STAFF REPORT: 05/14/2025

APPLICATION NUMBER: HDC2025-00196

ADDRESS: 1162 VINEWOOD

SCOPE: REPLACE WINDOWS, ADD WINDOWS TO EXTERIOR OF EXISTING WINDOWS, REPLACE STORM DOOR

Basement Awning Window Analysis

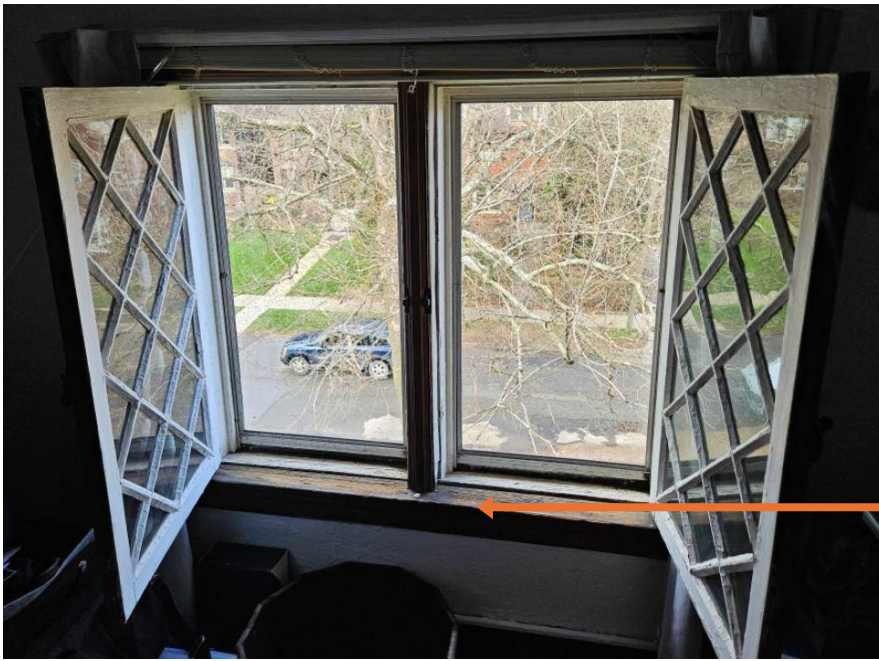
- Applicants' reasoning for replacement is that there is no way to keep them open, the exterior has metal grates over them, and they have rotting issues due to being at ground and below ground level.

- Customarily the Commission allows, though does not recommend, glass block for basement window replacement, but the existing historic windows have not been proven to be beyond feasible repair nor do the proposed window replacements address potential safety concerns.

- Staff has authority to approve glass block basement windows granted they meet the following applicable conditions:
 - The proposal meets the Secretary of the Interiors Standards; i.e., the alteration does not damage or destroy the property's historic character or character-defining features / elements.

- The glass block shall be located at the same plane as the existing historic window, set back from the face of the building wall.
 - The glass block shall be covered with the historic screen placed back in the window or with a new screen.

- Glass block will only be permitted in basement window openings.
 - Openings with glass block that are on the front or visible from a side street shall be screened with foundation plantings that cover the windows.

Storm door

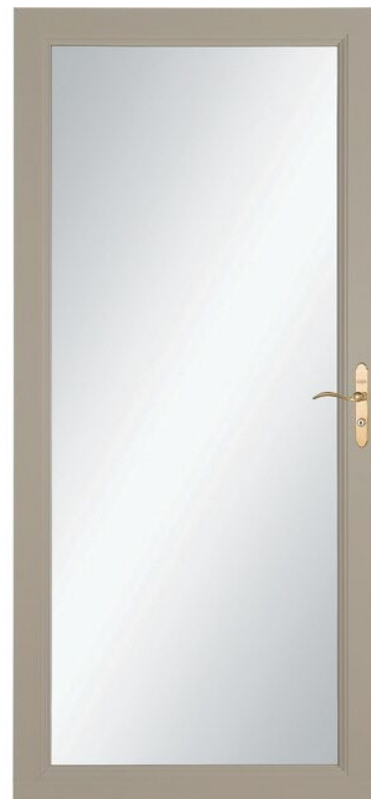
- The existing non-historic, though vintage, storm door is aluminum and divided into three sections.
- Due to not having architectural or historic significance and the proposed door being compatible with the property, the existing storm door can be replaced without impact to the historic character of the house.

Recommendation 2 of 2 – COA – Replace aluminum storm door for full-view storm door

Staff finds that the proposal for the remaining work items will not alter the features and spaces that characterize the property and district and therefore recommends the Commission issue a Certificate of Appropriateness for the work as proposed as it meets the Secretary of the Interior's Standards and the Hubbard Farms Historic District Elements of Design, with the condition that:

- Subject to staff approval of selected design/profile.
